ADDENDUM No. 01
September 7, 2016

AW Stanley Park and Aquatic Facility Improvements

New Britain, Connecticut
City of New Britain Bid Number 3896

The following changes and/or clarifications are hereby made to the Contract Documents dated August 22, 2016 for the above captioned project.

5 WOMENS DORMER ROOF FRAMING PLAN - ALT #11
1/8" = 1'-0"

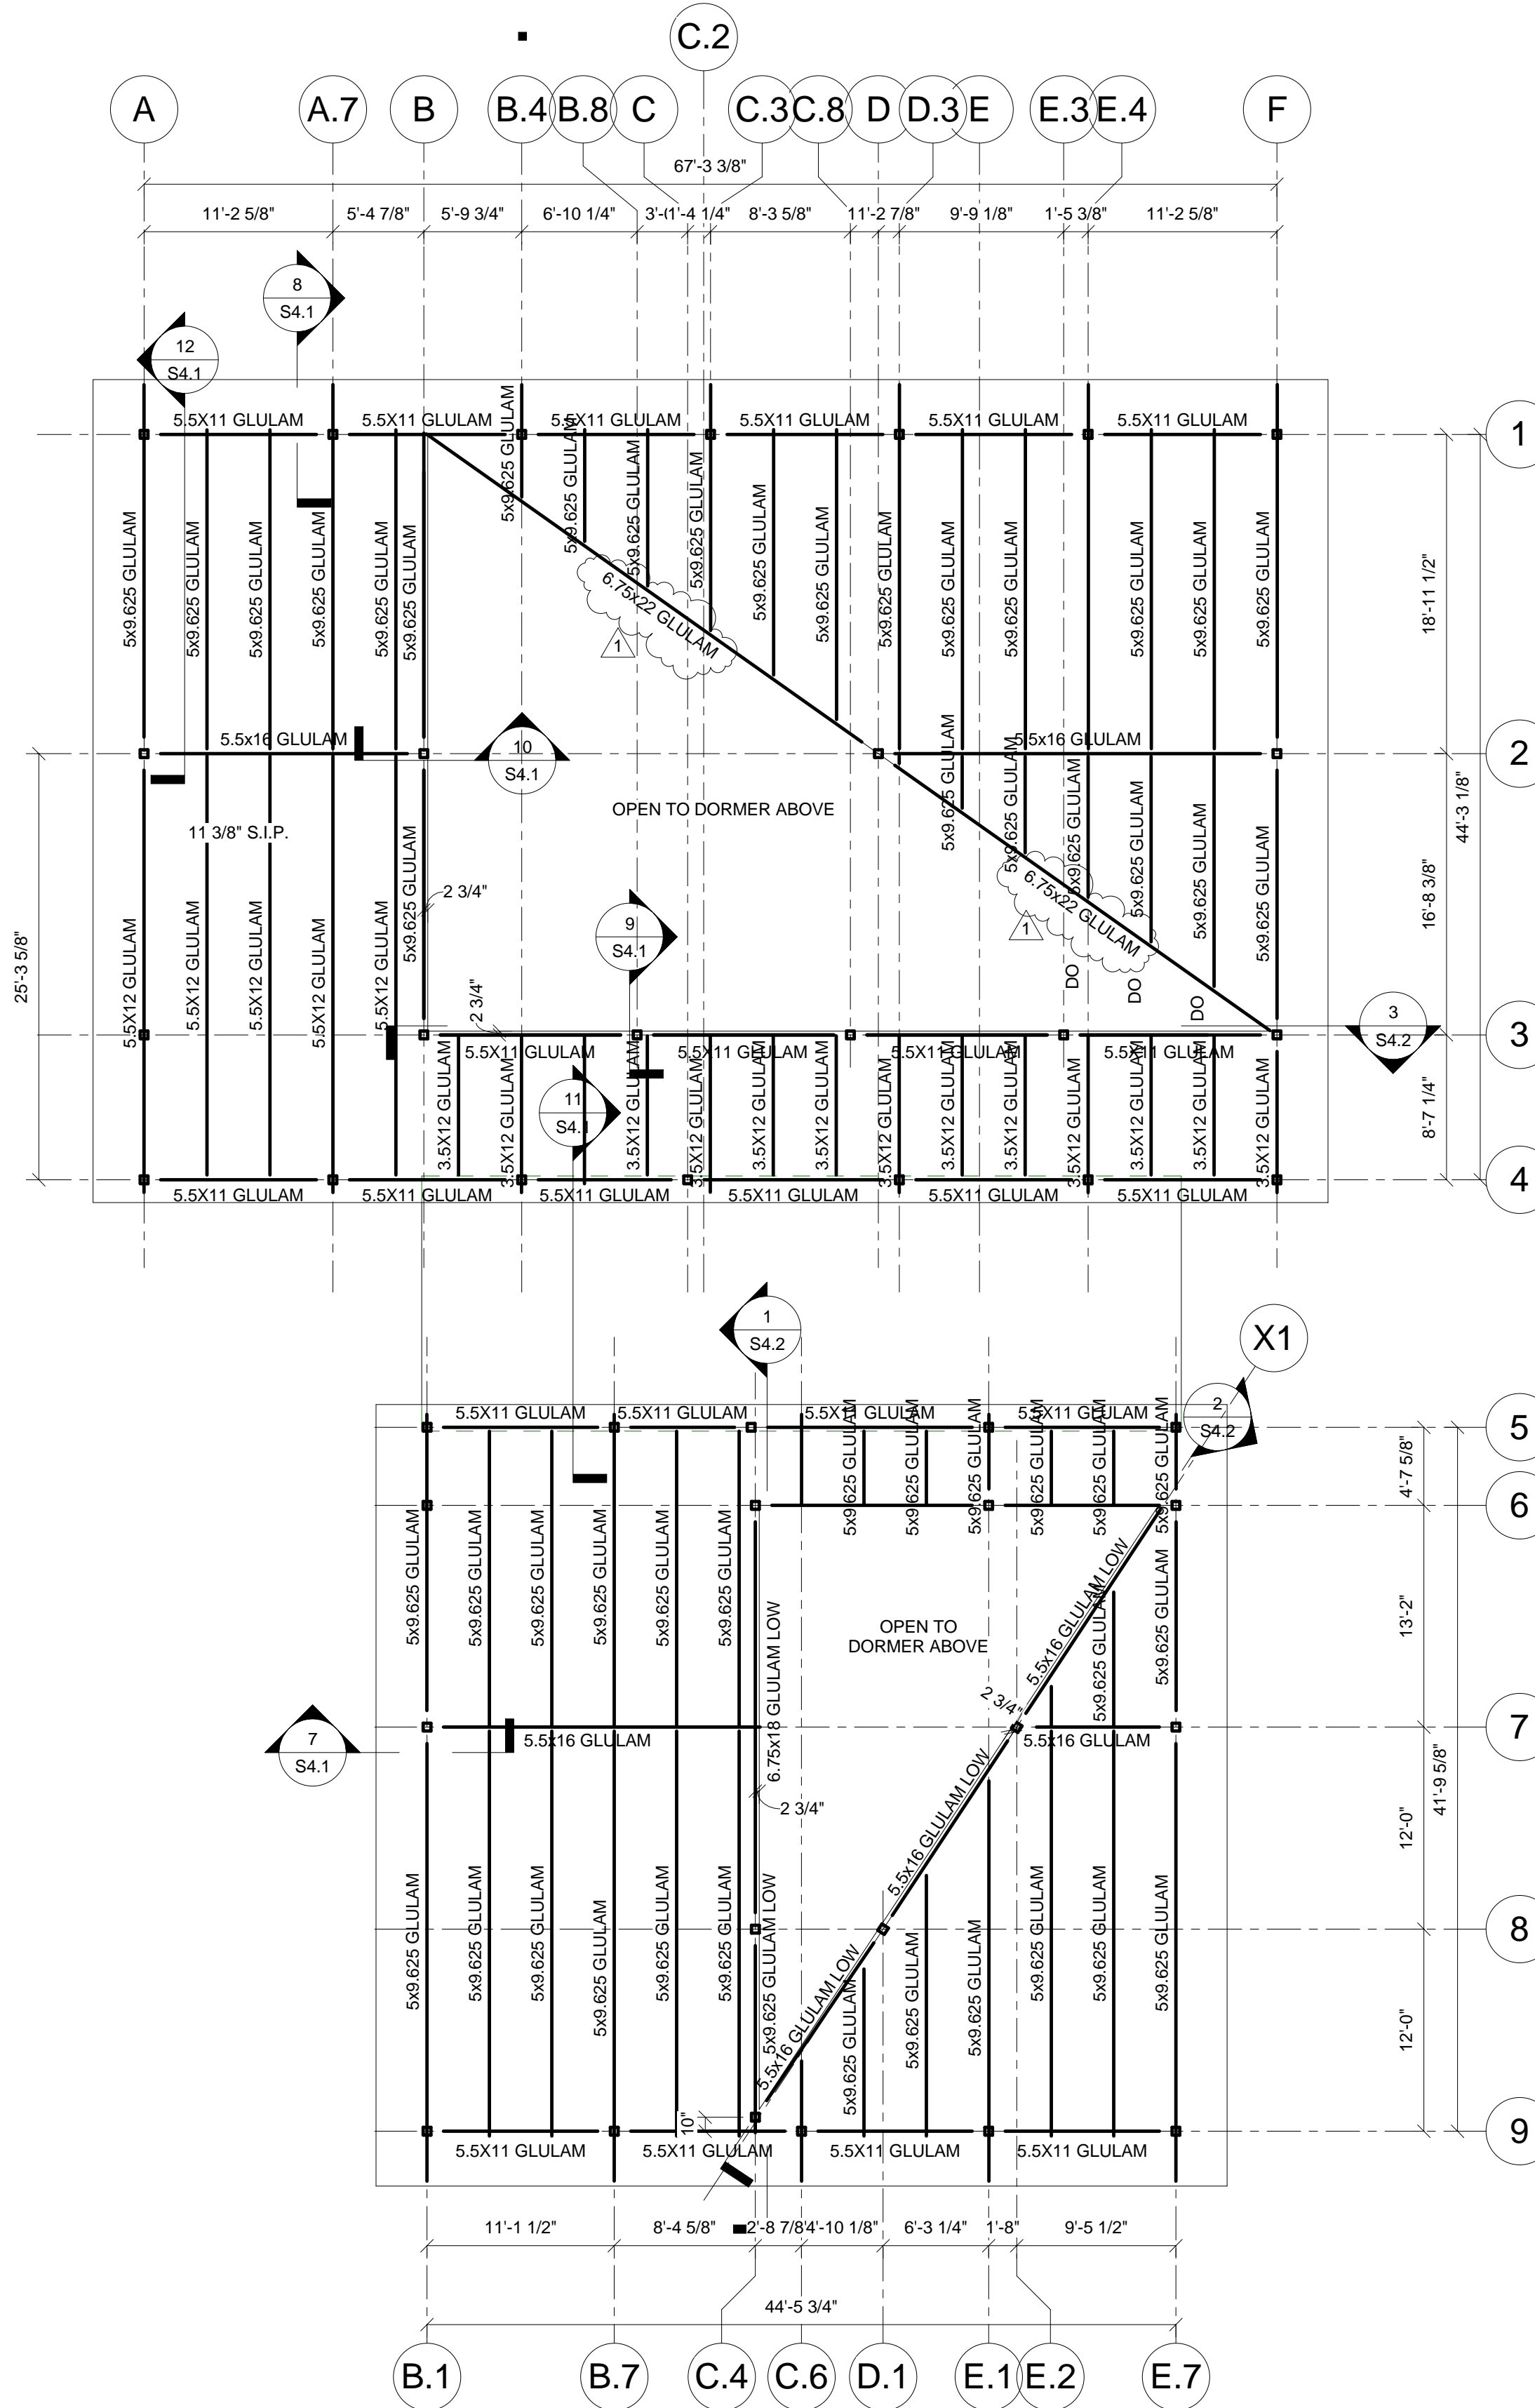
12) Drawing S1.1

- a) Add beam sizes as noted in SSK-S1.1-01, dated 9/7/16.
- b) Change SIPs Panel Dimension from 11 3/8" to 6 1/2". The underside of SIPs panel elevations shall remain unchanged. The thickness of the roof will be less and elevation call-outs and dimensions on building elevations, sections and details shall be adjusted accordingly.

1 REVISED FOR HAUNCHES ON ALL SIDES
SCALE: 3/4" = 1'-0"

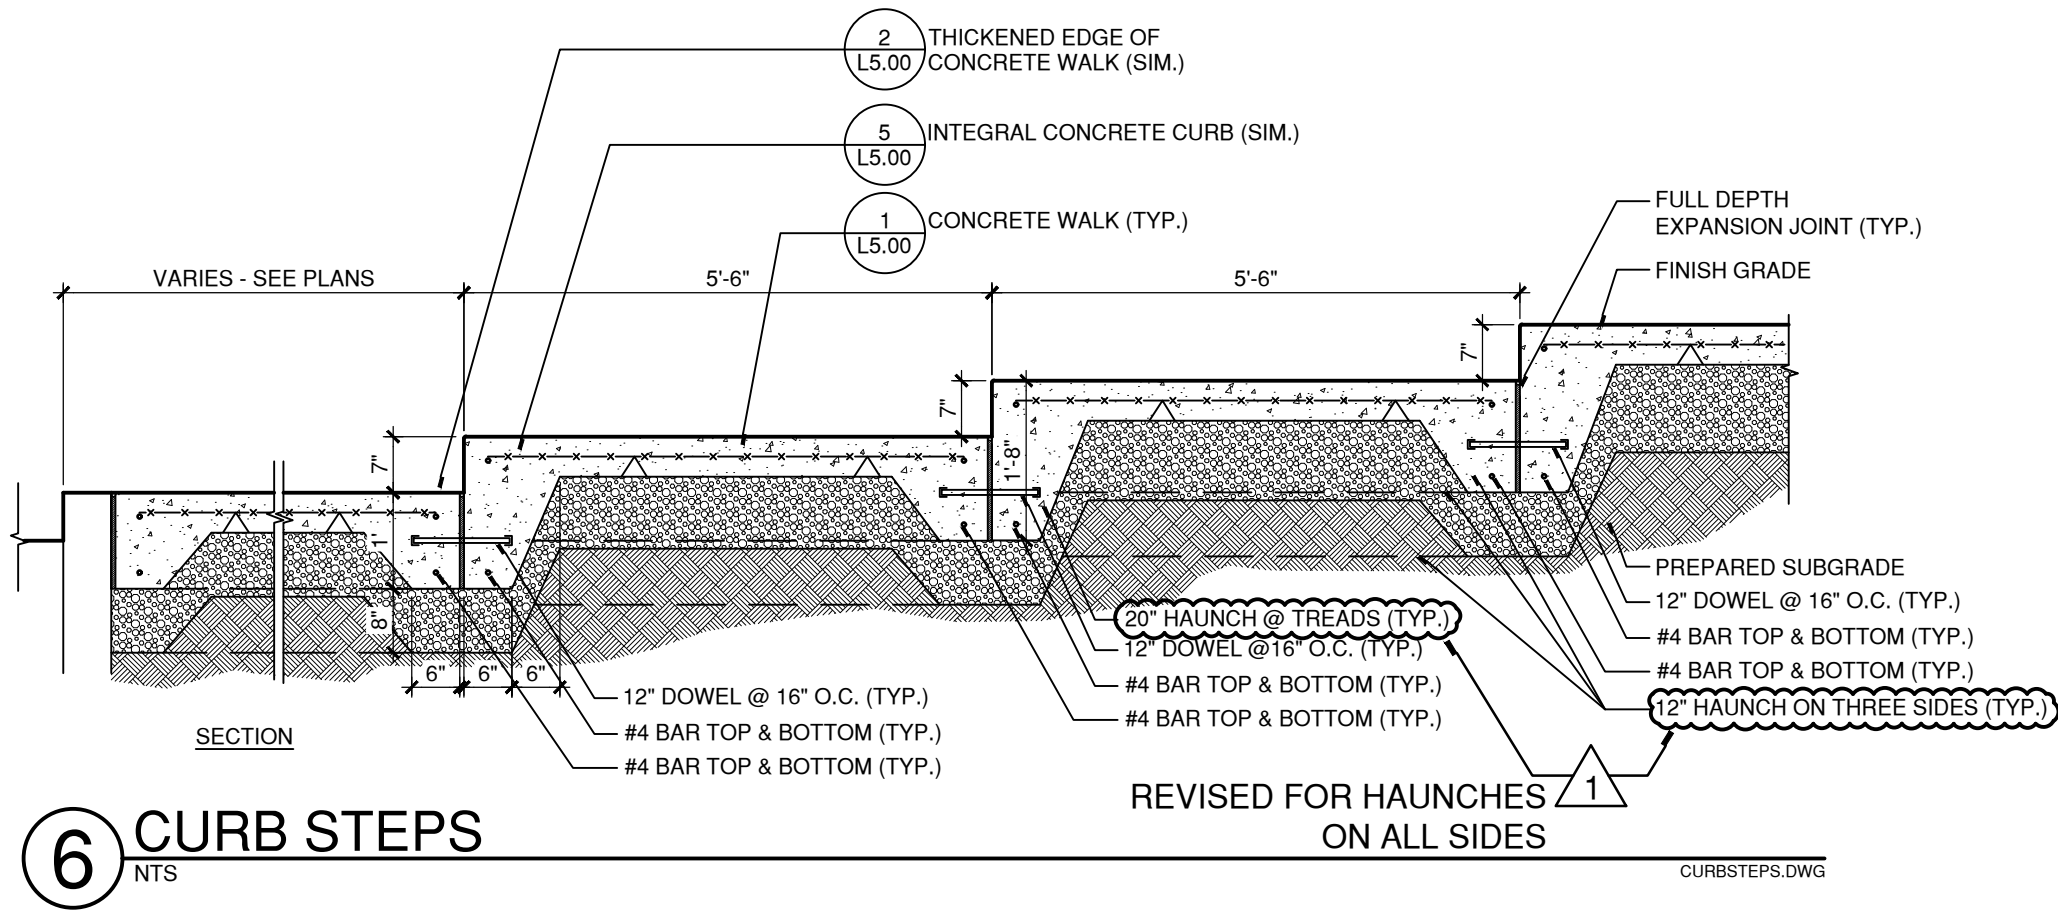
11) Drawing L5.00

- a) Modify Curb Steps as indicated in LSK-L5.00-01, dated 9/7/16.

ADDITIONAL INFO
CSK
C2.2-01
SHEET TITLE

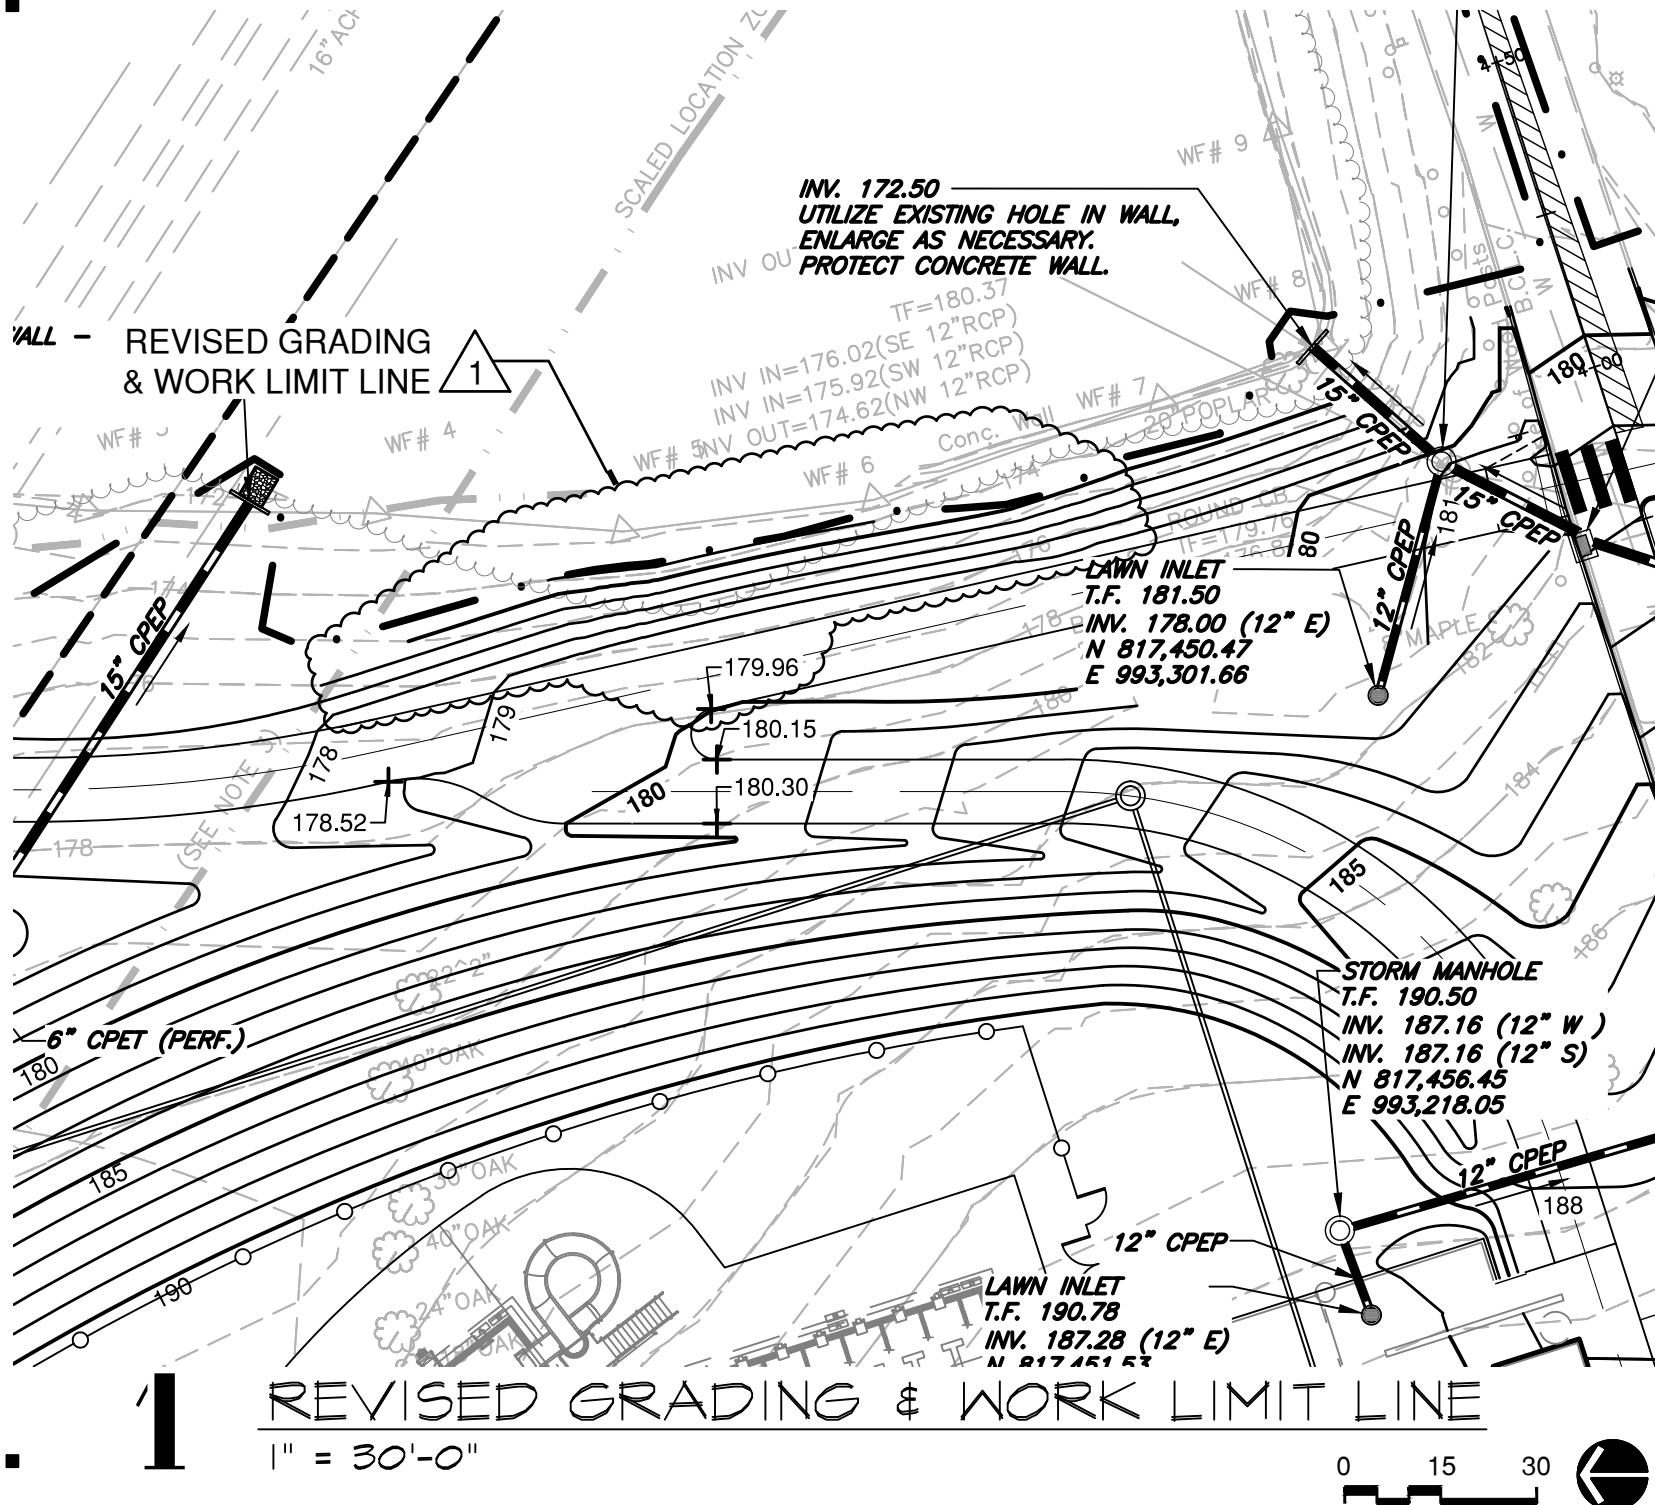
9) Drawing C2.2

- a) Modify Grading and Work Limit Line, as indicated in CSK-C2.2-01, dated 9/6/16.

ADDITIONAL INFO
CSK
C3.2-01
SHEET TITLE

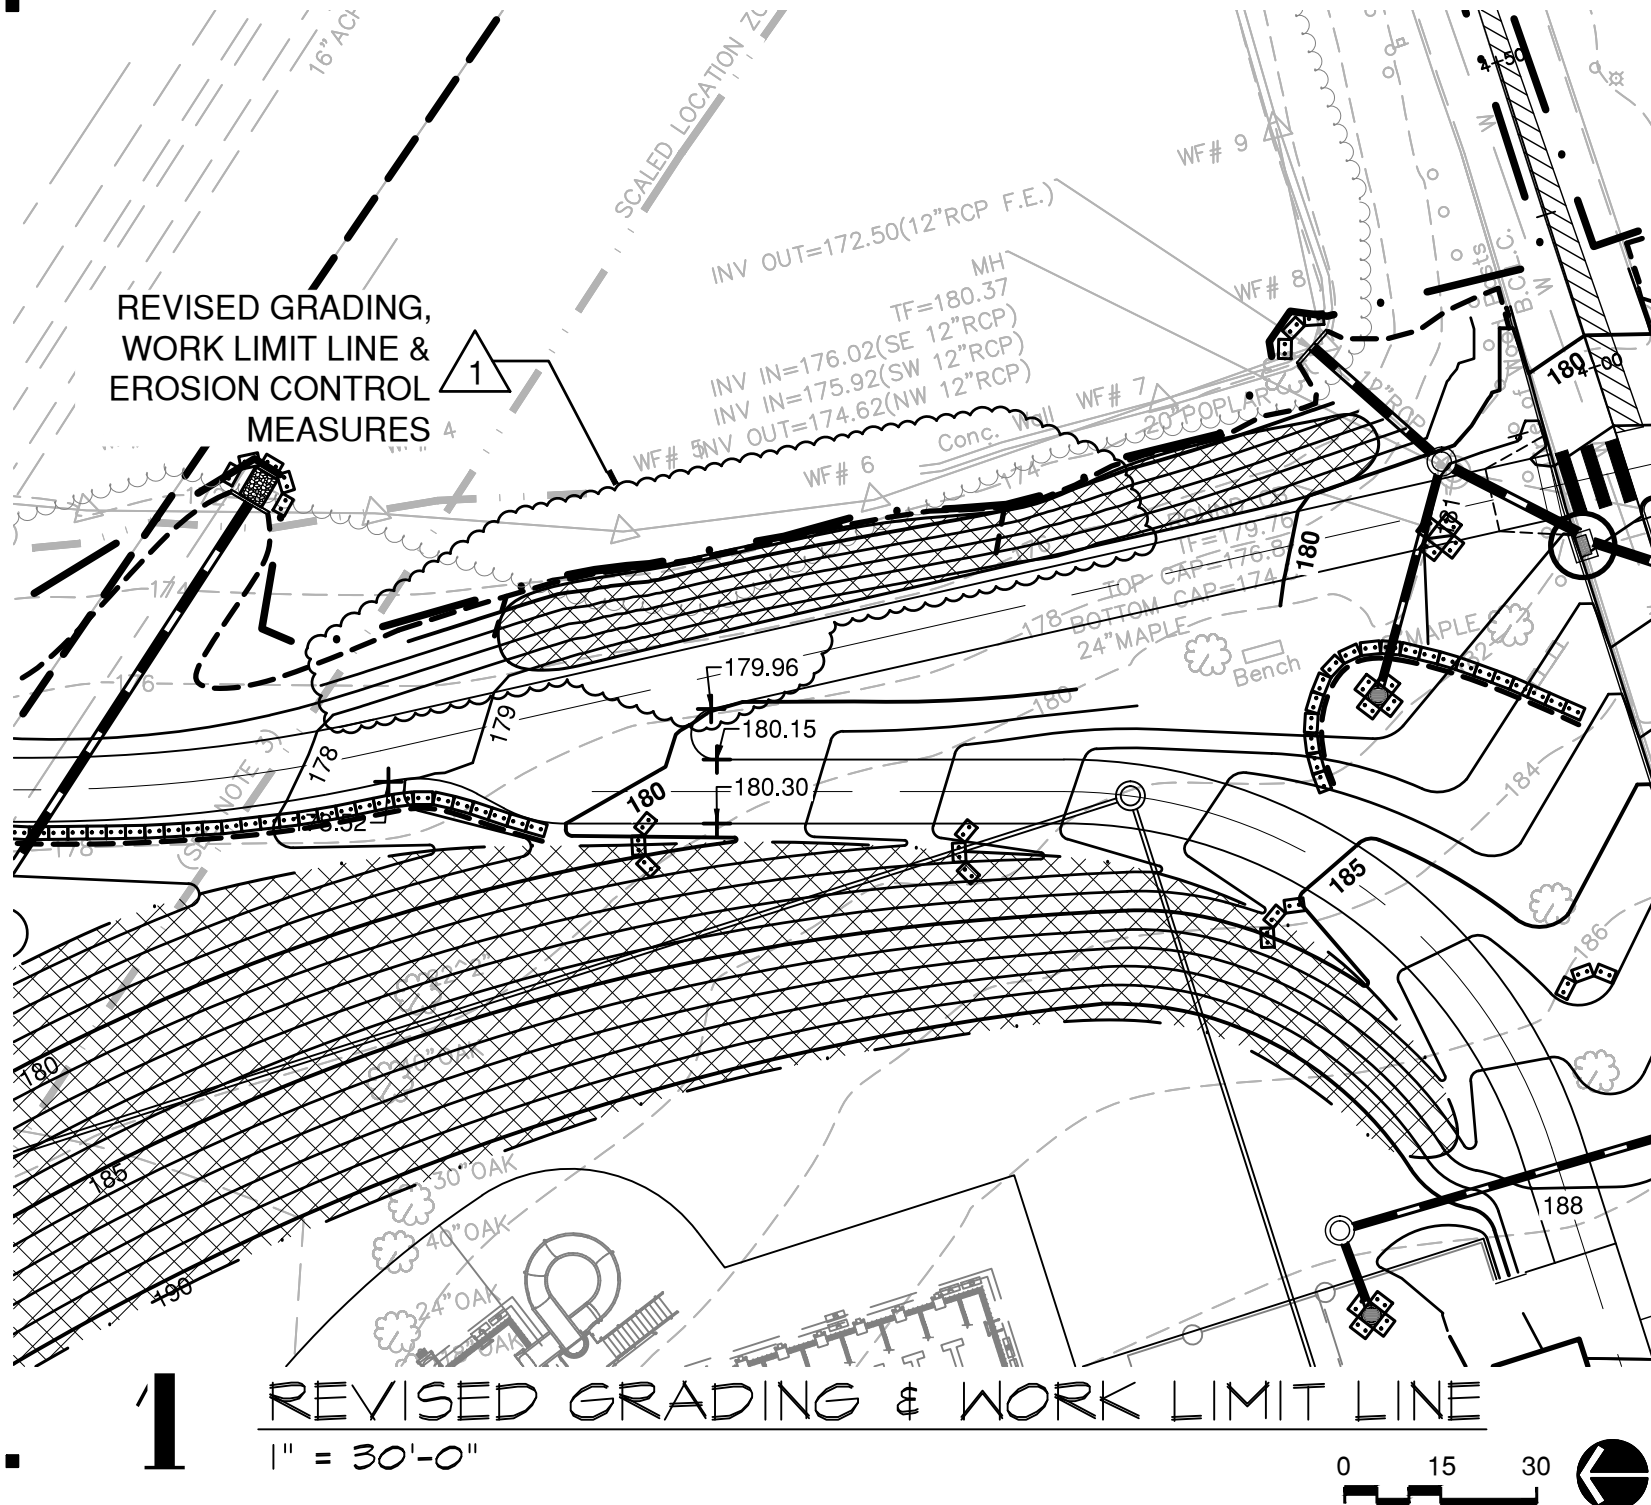
10) Drawing C3.2

- a) Modify Grading and Work Limit Line, as indicated in CSK-C3.2-01, dated 9/6/16.
